NUREG/CR-3300
SAND83-1118
Vol. 1

Review and Evaluation of the Zion Probabilistic Safety Study

Plant Analysis

Figure 2.7.1-7 Hazard Curve Comparison - $M_D = 5.6$ Cutoff

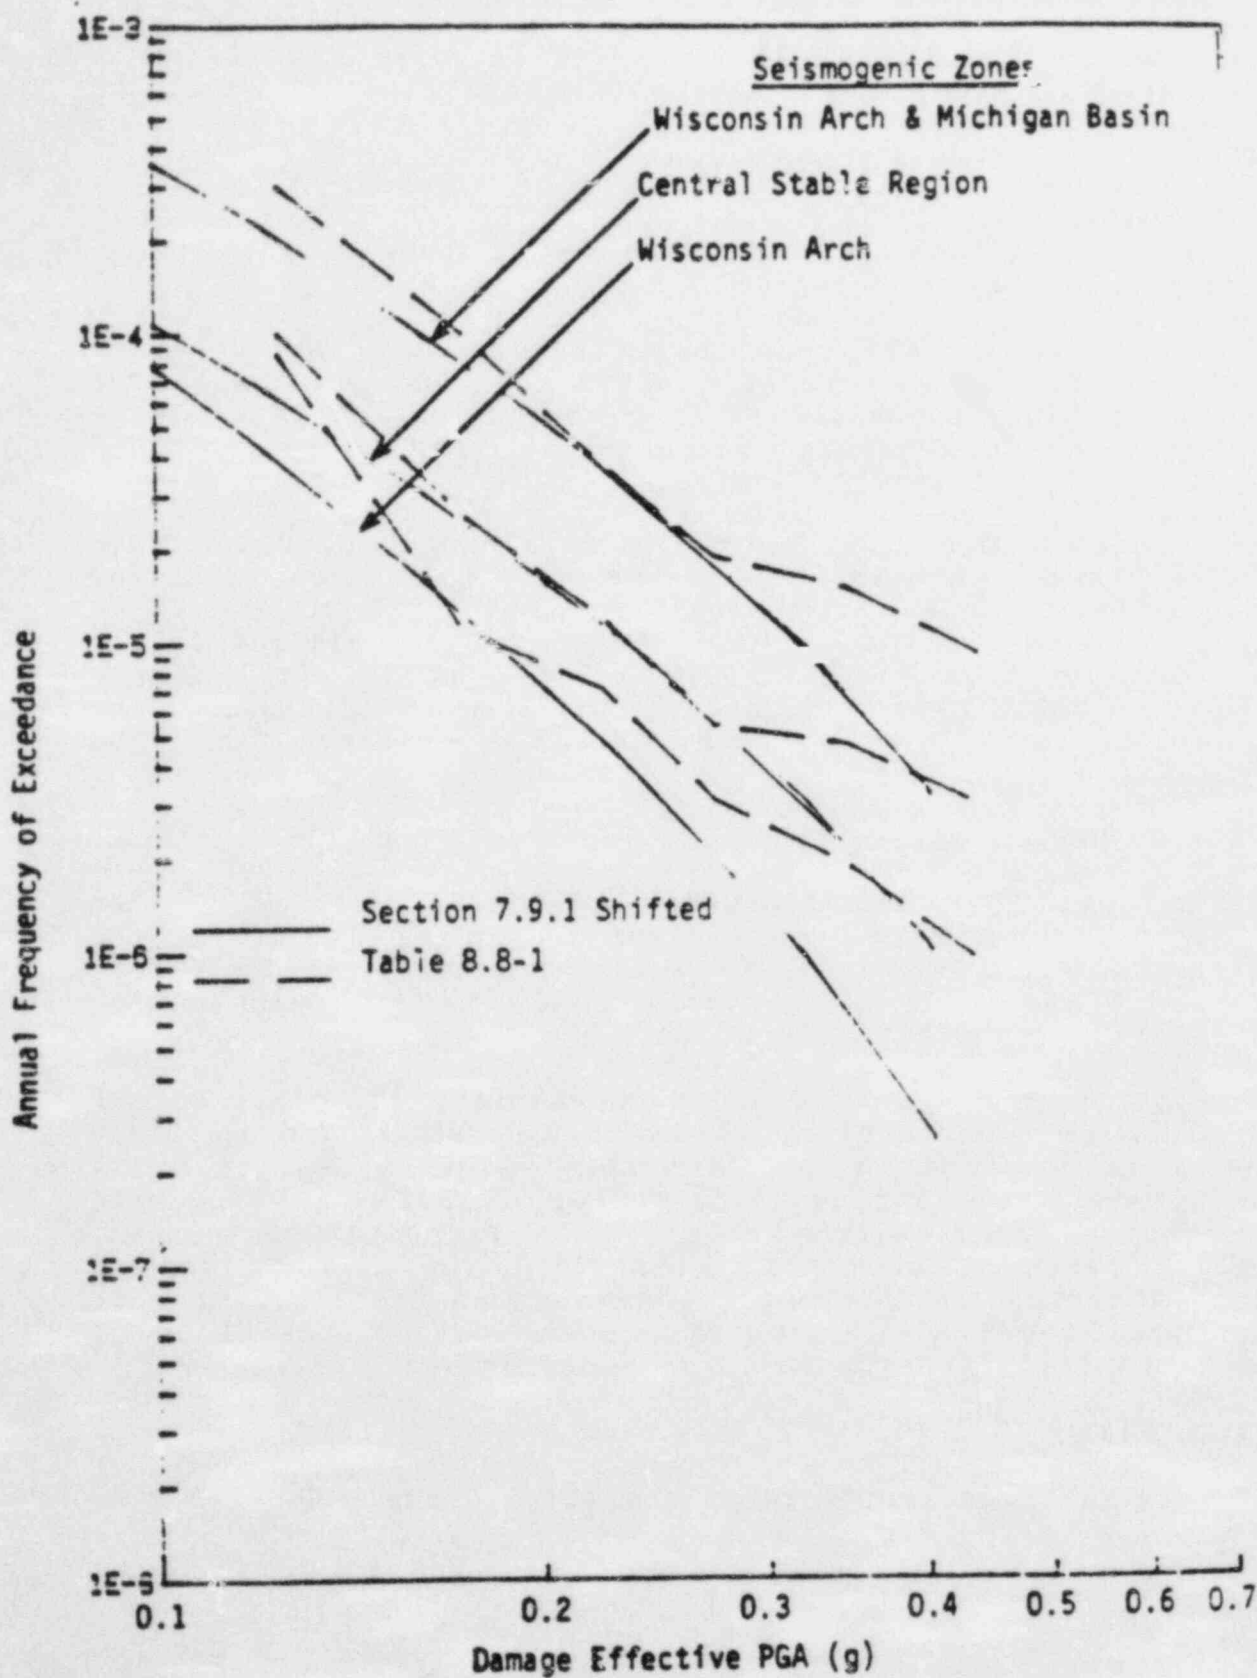
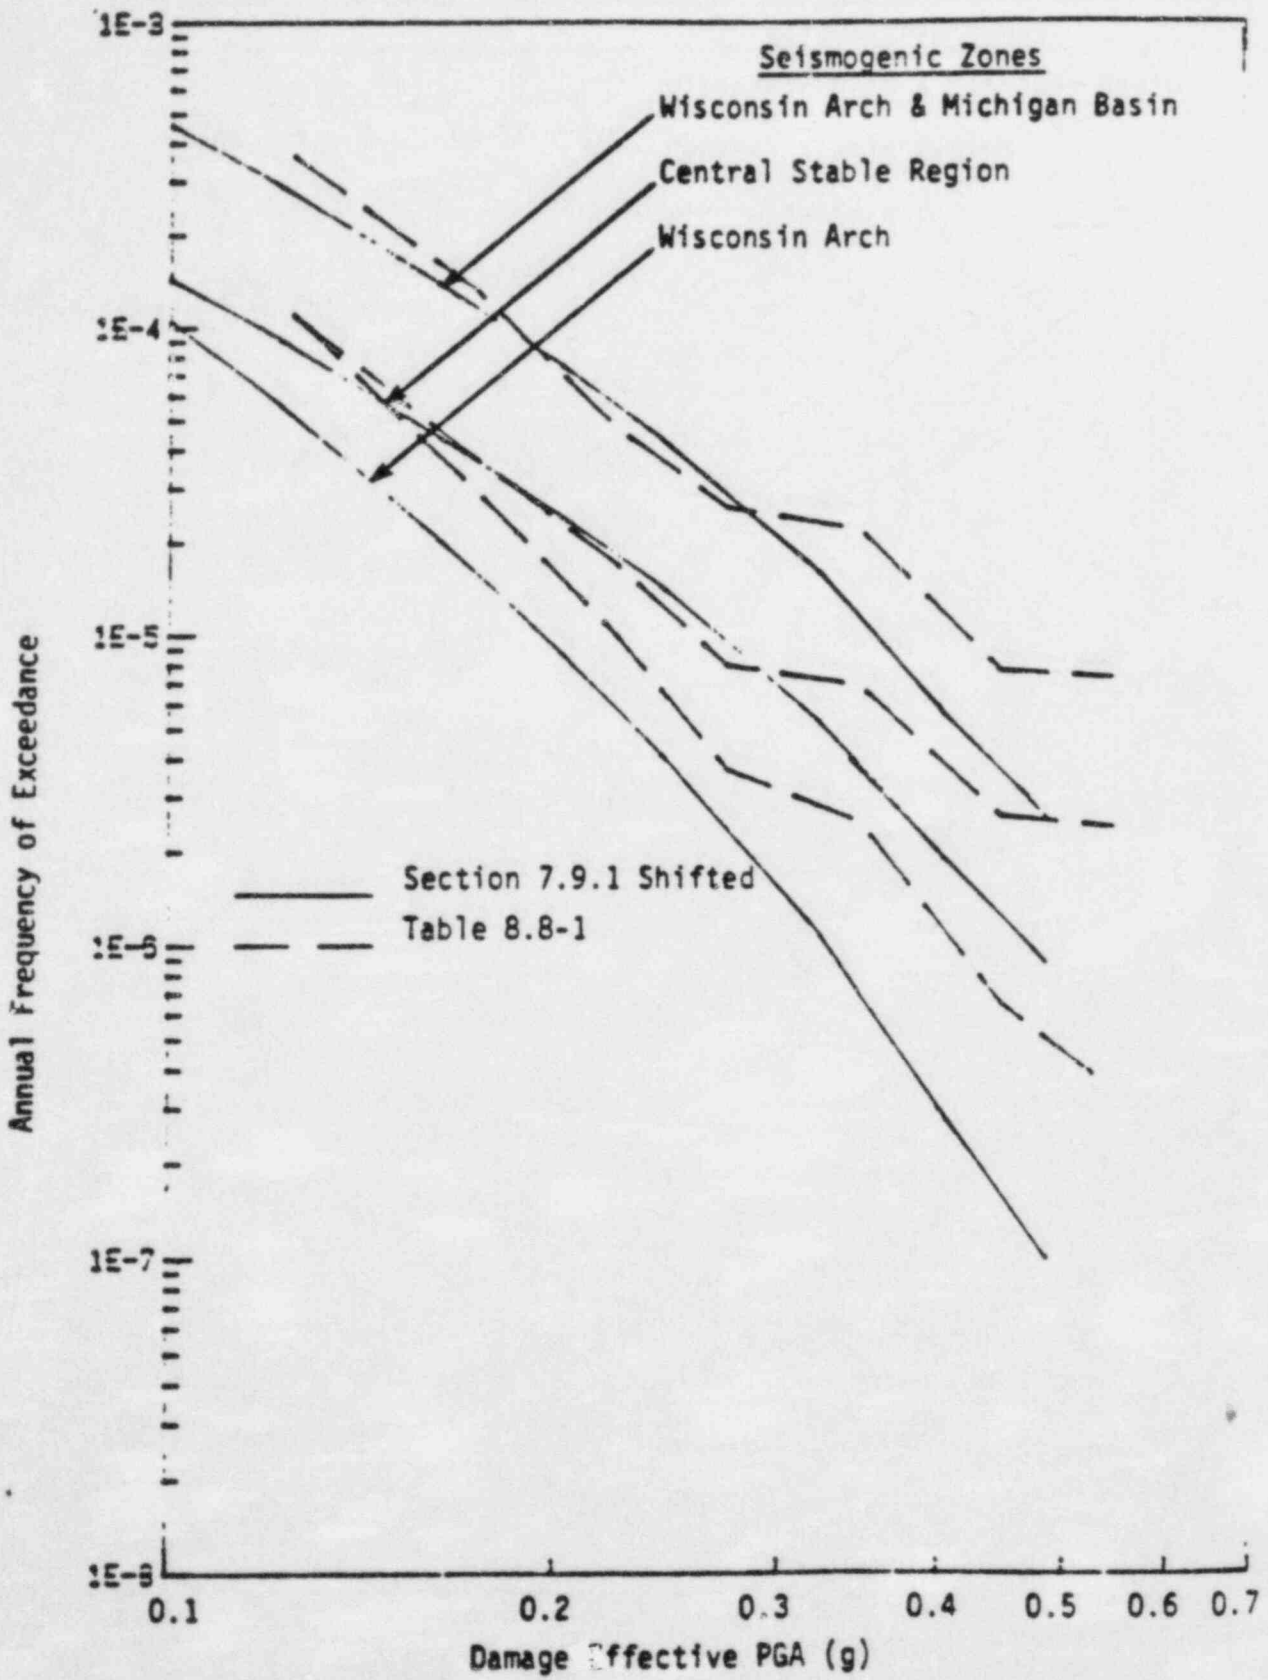
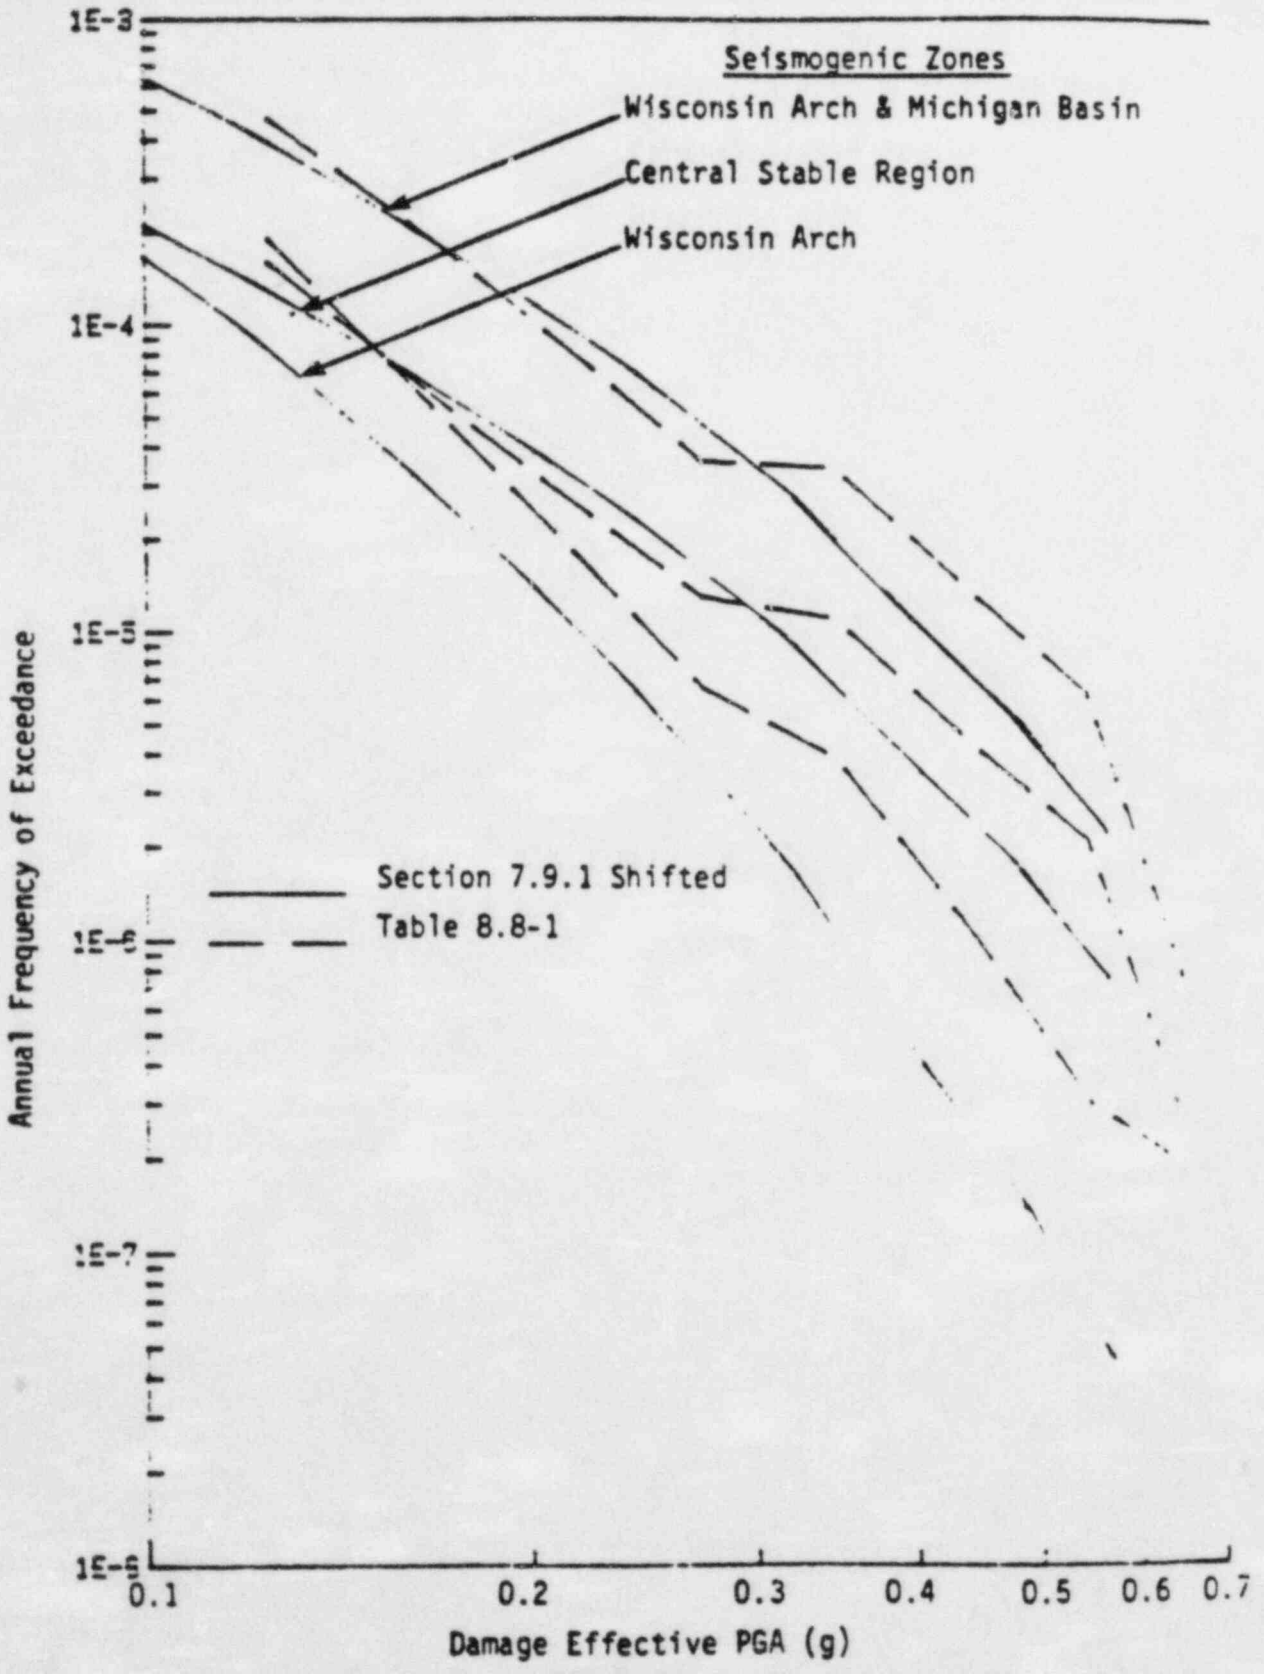
We feel that the frequency of acceleration values at different probability levels given in Table 8.8-1 are at too coarse a spacing to give stable frequency of core-melt values in the tails of the probability density function for core melt. (See ZPSS Figure 7.2.5.)

Figures 2.7.1-7 to 2.7.1-9 show plots of these values (with obvious corrections to typographical errors in Table 8.8-1) as compared to the data obtained from Section 7.9.1 which have been shifted by a factor of 1.23 and truncated for maximum acceleration values. We expected the corresponding pairs of curves to coincide. The differences are about 30 percent. The effect on the mean frequency of core melt would be small. However, the effect on the tails of the probability density function would be much larger.

Figure 3.1-1 Partial Fragility Curves - Linear Scale

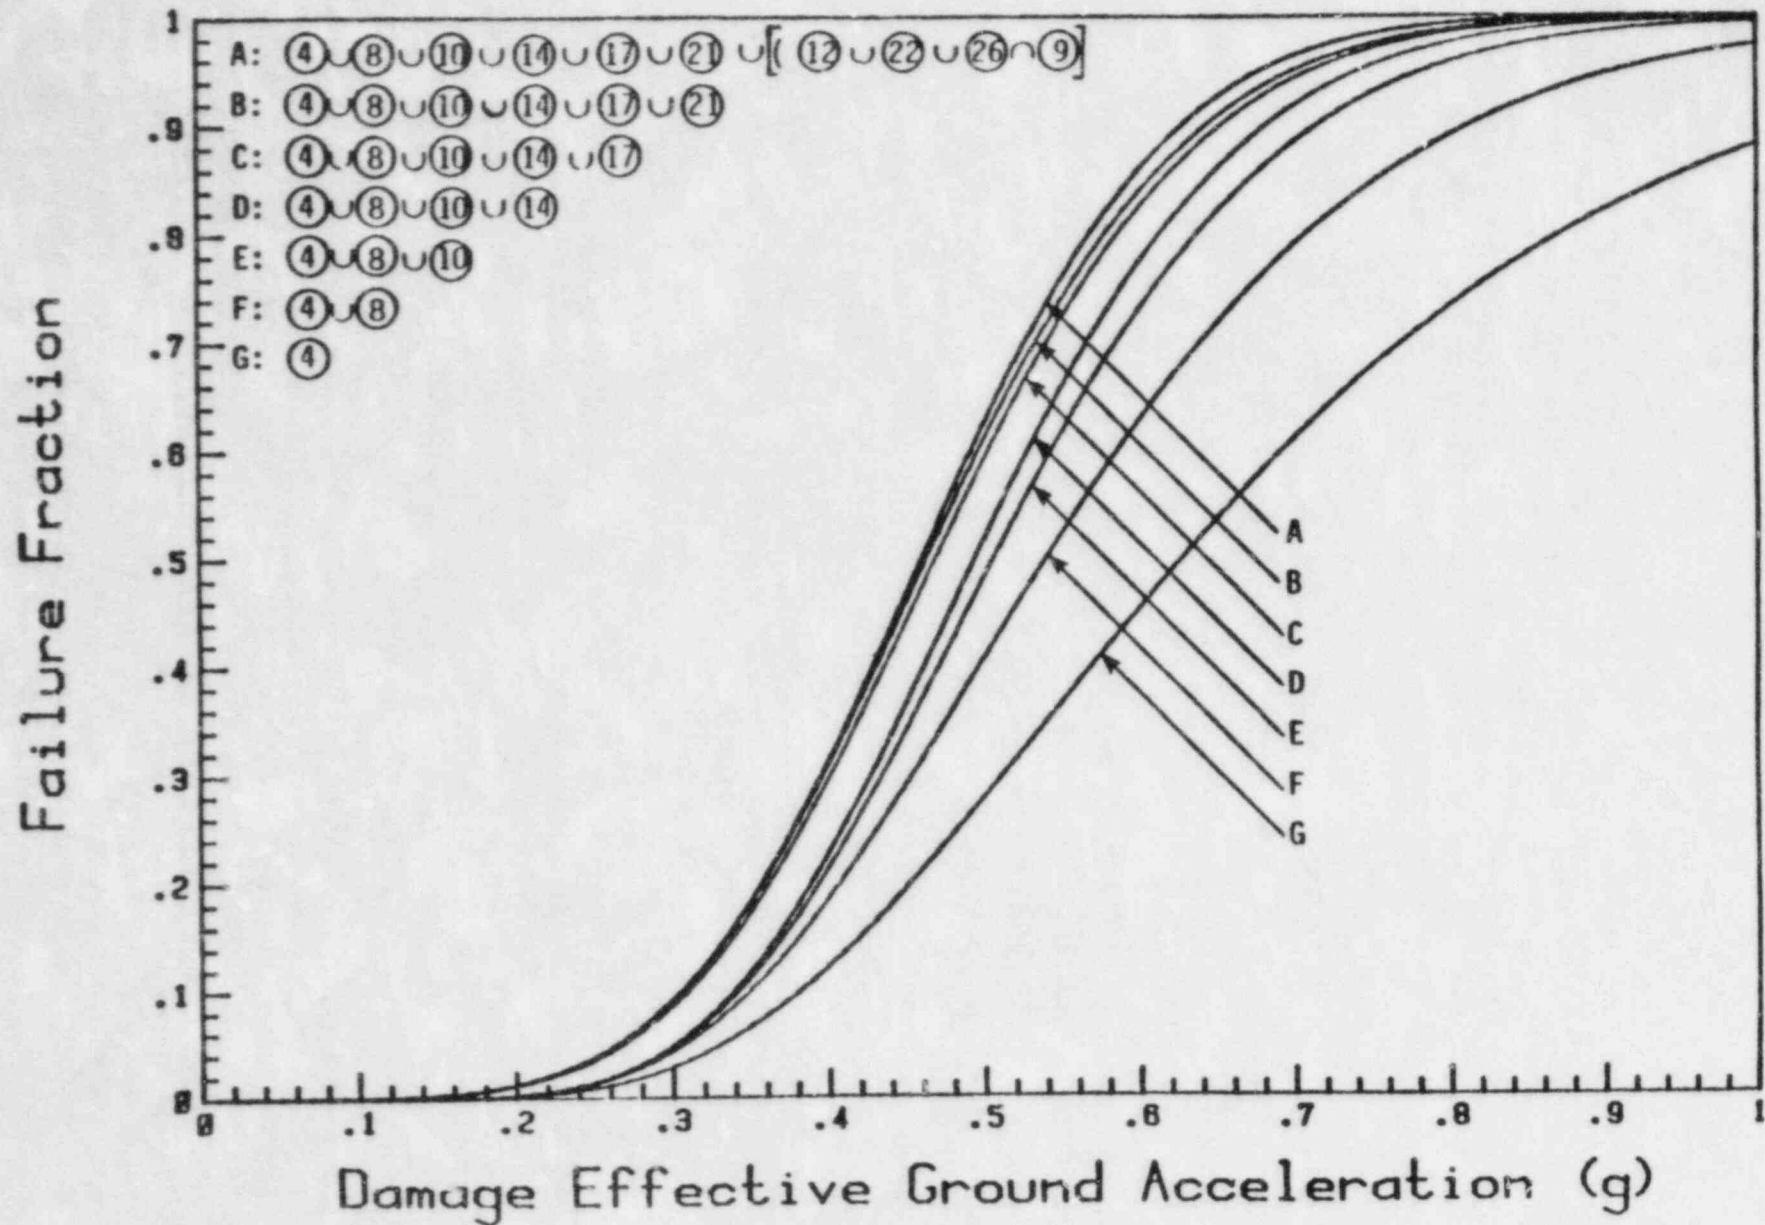
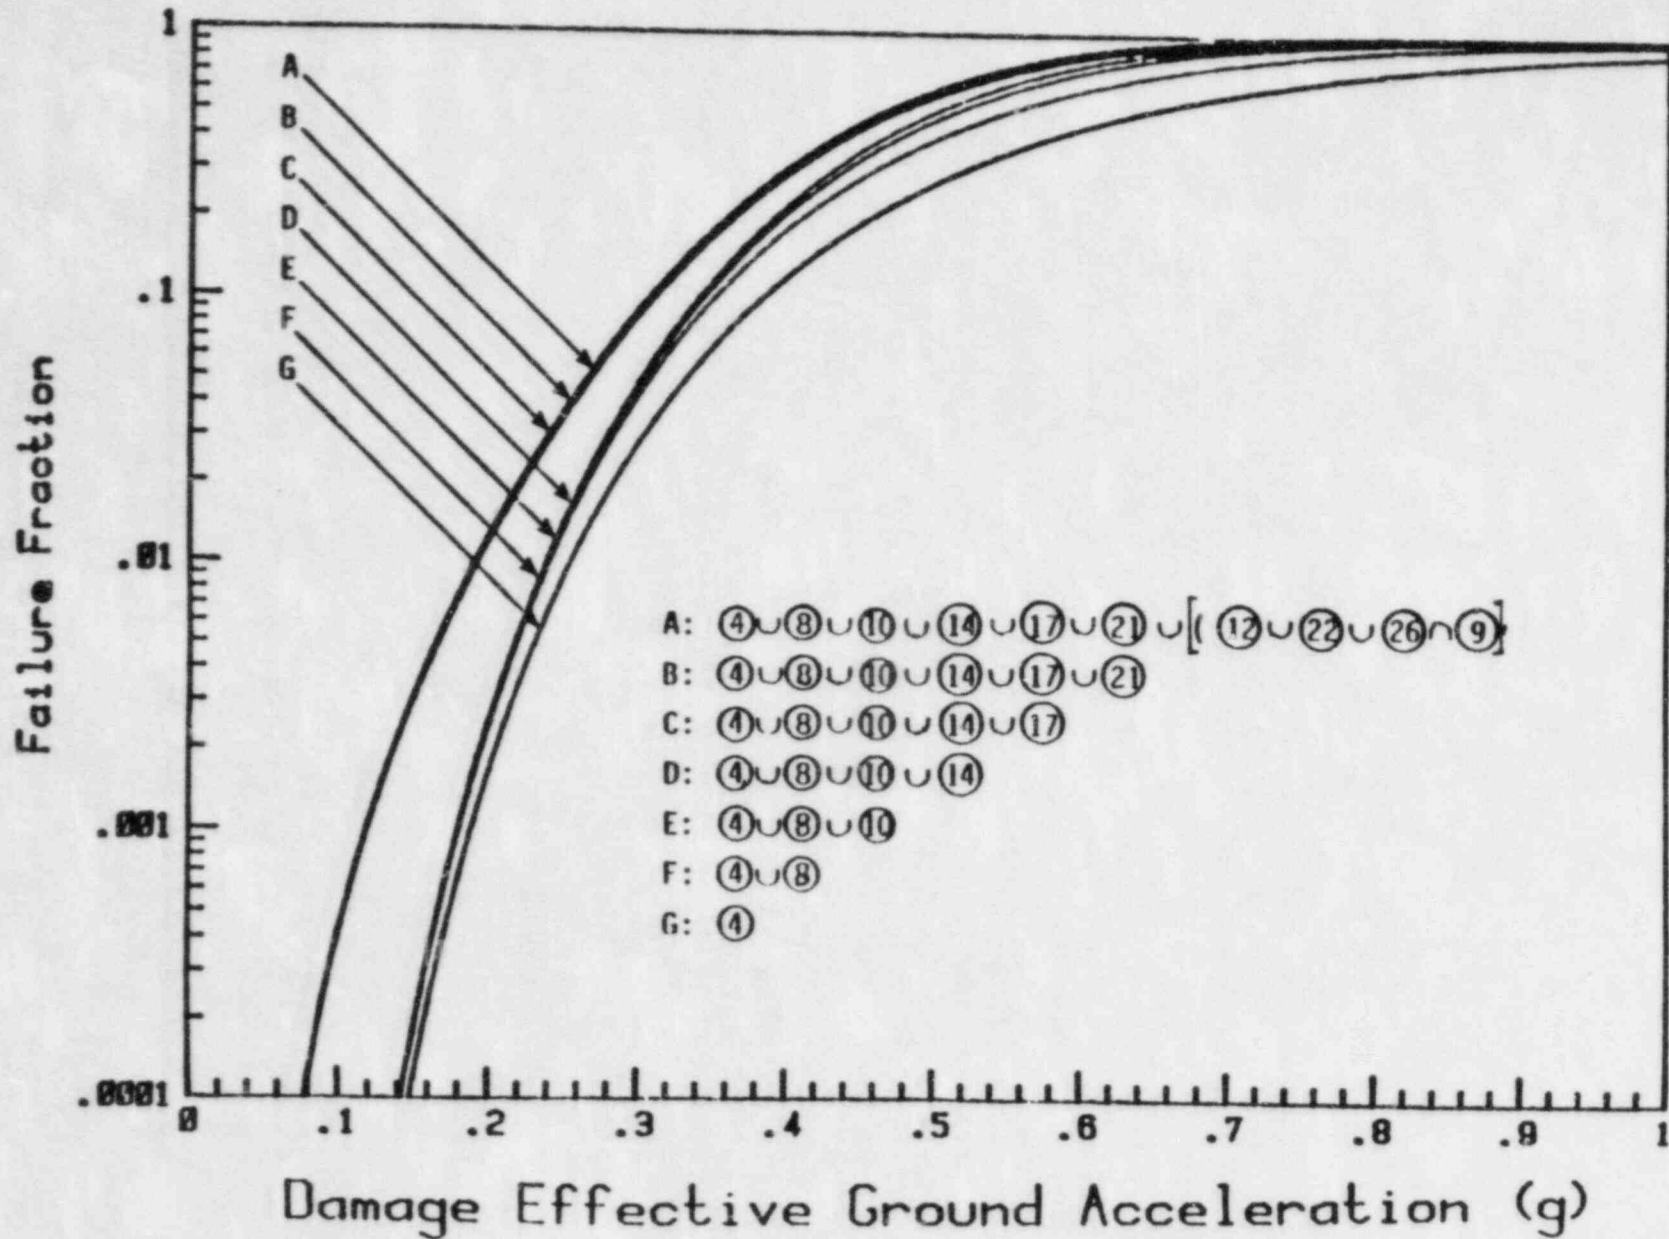
Figures 3.1-1 and 3.1-2 show the relative contribution of the above-listed 10 items to the total frequency of core melt. The failure fraction versus damage effective ground acceleration is shown for linear and logarithmic scales in these two figures. As shown, the curves become progressively higher (i.e., larger failure fraction) as more and more items are included in the Boolean equation for core-melt failure. Note that in developing these curves the randomness and uncertainty were combined.

Several observations which give perspective to the importance of each structure or equipment item can be seen from these curves. The most important contributor to core melt is the service water pumps, which are the weakest components. The next most important item is the Auxiliary Building shear wall. As explained previously, the integration of the hazard and fragility curves depends primarily on acceleration values above 0.3g. For ground accelerations above 0.3g, neglecting the contribution (i.e., based on the

fragility parameter given in the ZPSS) from all other structures or equipment, would result in underestimating the failure fraction by a factor of only three (a moderate effect). In terms of the probability distribution of the frequency of core melt (i.e., Figure 7.2-5), the mean value would also follow this same relationship. However, the lower tail of the density function would be affected more severely by the elimination of other items. Thus, in order for a major change to occur in the mean frequency of core melt due to fragility effects, the strengths of a number of the structure or equipment items would have to drop down to or below the strength of the service water pumps (or the strength of the service water pumps would have to decrease).

A jump in the probability of failure occurs when item 17, which is the 125 VDC batteries and racks, is included in the Boolean expression (see Figure 3.1-2). This is due to the relatively high uncertainty value (i.e., $\beta_U = 0.63$) for this equipment.
